MCLAREN TRAFFIC ENGINEERING

1 August 2017 Reference: 17230.01FA

LETTER RESPONSE TO DEPARTMENT OF PLANNING AND ENVIRONMENT WITH REGARD TO THE WOOLOOWARE BAY TOWN CENTRE AT 471 CAPTAIN COOK DRIVE, WOOLOOWARE

FIGURE 1: CENTRE ENTRY AND EXIT POINTS

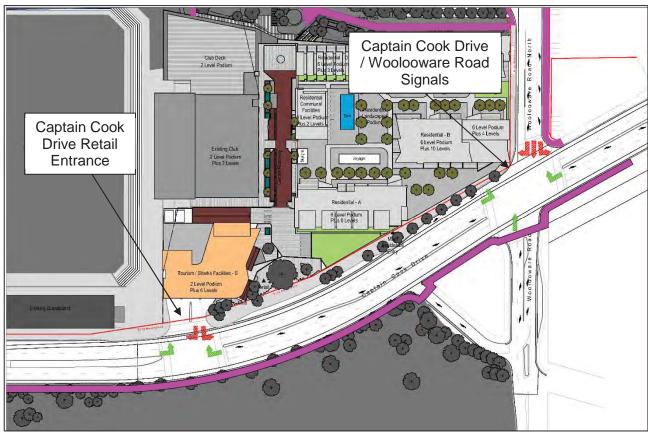
5. Further details on the management of access and parking for each of the land uses, including consideration on whether shared or separate access will be provided, ease of access for visitors and dispersion of traffic to minimise queuing on both arrival and exiting the site.

Two separate access points are provided for the development, via a signalised intersection on Captain Cook Drive and via Woolooware Road (N). These access points have previously been assessed and approved as part of the original Concept Plan and Project Application. No changes are sought to the external configuration of these traffic signals/access points as part of MOD 2.

The access from Captain Cook Drive will directly serve:

- Residents;
- · Hotel patrons and staff;
- Vehicles dropping off at the club;
- Access to the retail/club car park level 3 (internal ramps provide access to other car parking levels).

The access from Woolooware Road (N) will directly serve:

Access to the retail/club car park – level 1 (internal ramps provide access to other car parking levels).

The entry and exit points of the development are illustrated in **Figure 1**.
